PIK/L3756-1 Rev A/cam

29 May 2026

**RE: TECHNICAL PEER REVIEW REPORT NO. 1 FOR FAST TRACK APPLICATION
FTAA-2512-1153**
– **APPENDIX N: HYDROGEOLOGY ASSESSMENT**
– **APPENDIX I: HYDROLOGY ASSESSMENT**

Figure 1 : Visual summary of Geological units and spatial relationships, Taharoa, based on north-south sectional alignment. Not to scale.

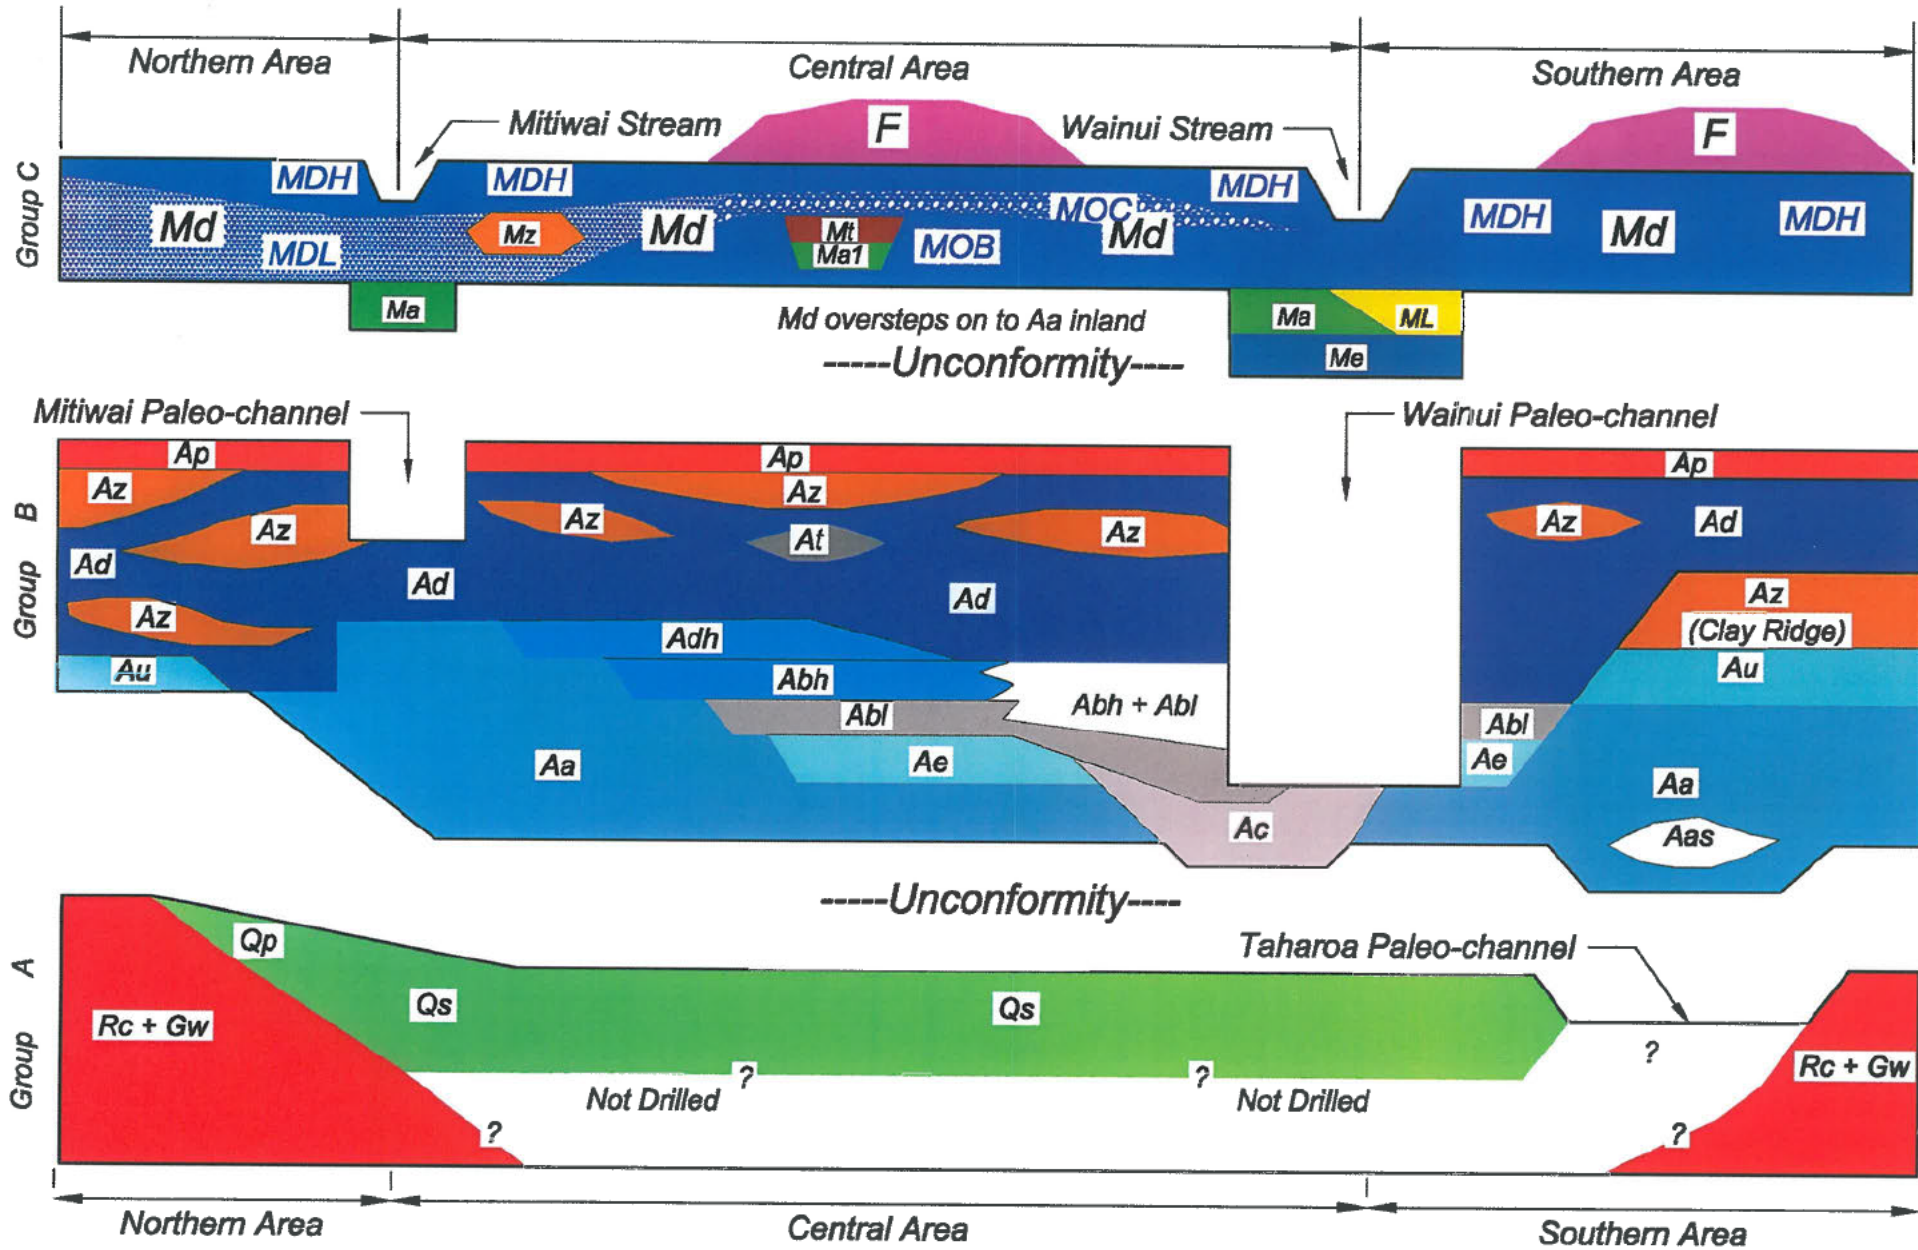
Figure 1 from Geotechnics (2014) shows the Mitiwai Stream channel incised into moderately permeable black sand deposits. The calibrated hydraulic conductivity plot presented in Appendix A, Figure 10, shows the Mitiwai Stream directly underlain by a low permeability zone which limits predicted stream depletion effects.

- 2a. Please provide an assessment of the Table 6 – Summary of Slug Test Results, against soil texture from each piezometer test zone.*
- 2b. Please provide the groundwater model assigned hydraulic conductivity settings for the Appendix A cross-sections A-A', B-B', C-C' and D-D' so that this data can be compared to the information requested in RFI 1 above.*
- 2c. Please provide verification of the low hydraulic conductivity setting adopted for the Mitiwai Stream Layer 1 area.*
